UNITED STATES
DEPARTMENT OF THE INTERIOR
BUREAU OF LAND MANAGEMENTFORM APPROVED
OMB NO. 1004-0137
Expires: January 31, 2018**SUNDRY NOTICES AND REPORTS ON WELLS**
*Do not use this form for proposals to drill or to re-enter an abandoned well. Use form 3160-3 (APD) for such proposals.*Internal No.
NMLC032096B

EAST BLINEBRY DRINKARD UNIT 21

Apache is requesting permission to convert this well to injection, per the attached procedure and WBD's.

Conditions of Approval

Downhole Well Profile

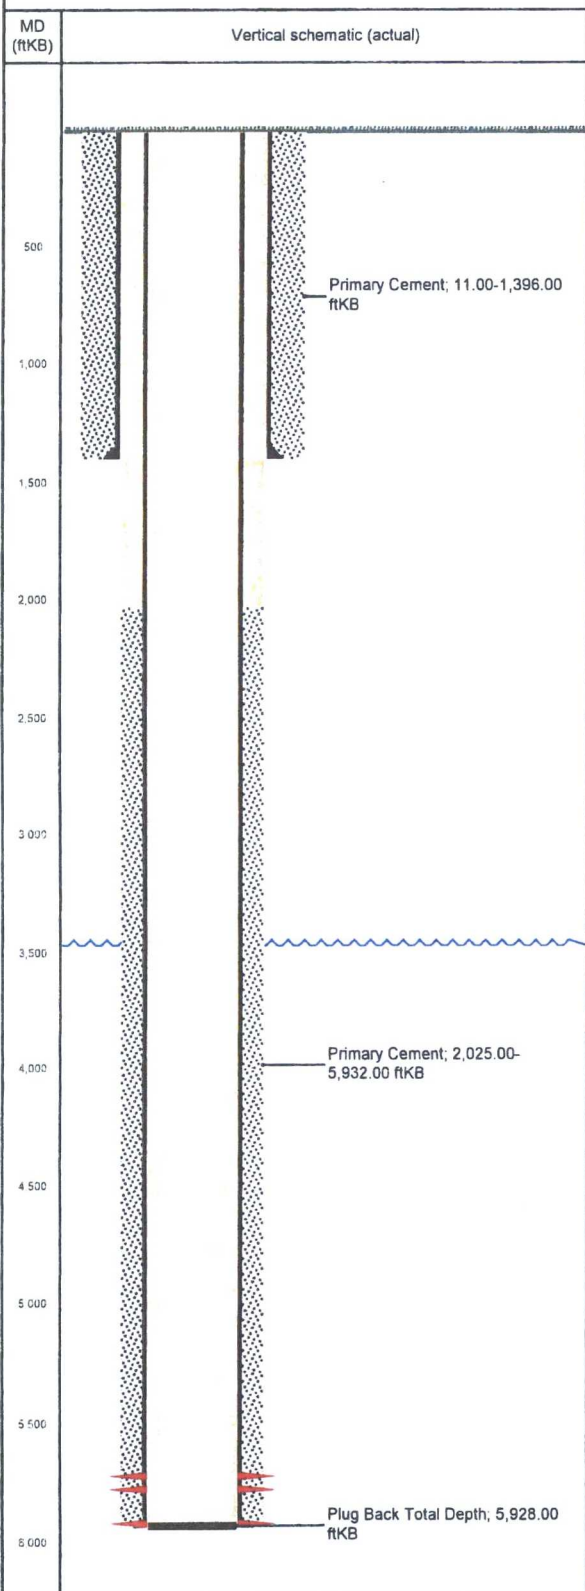
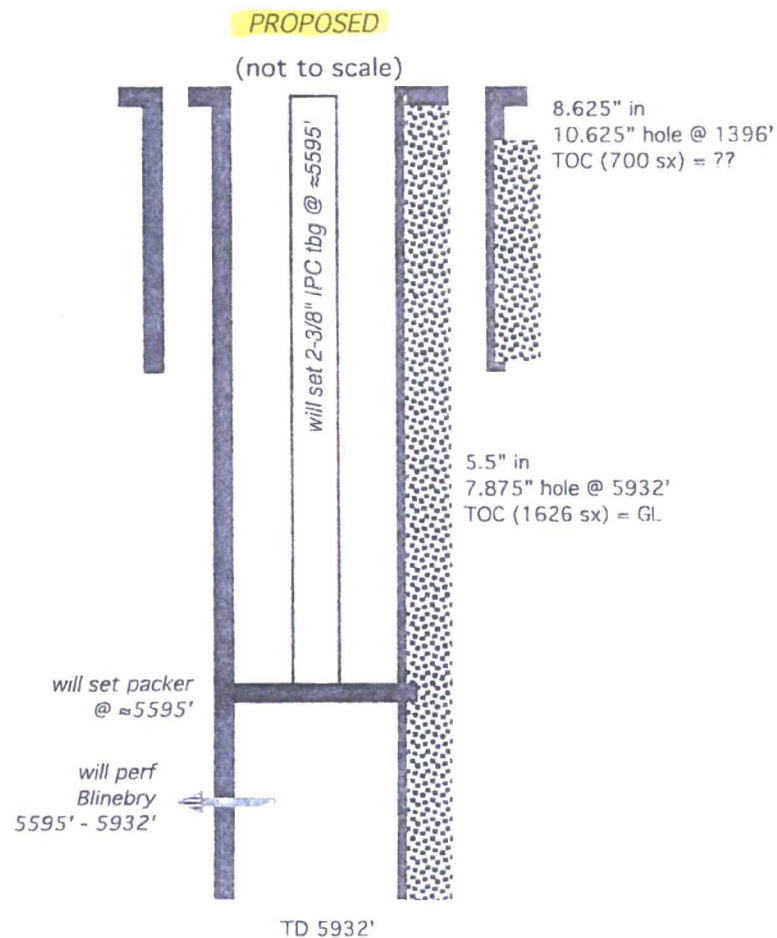
Remedial work needs to be done on 5 ½" casing in order to bring cement to surface.
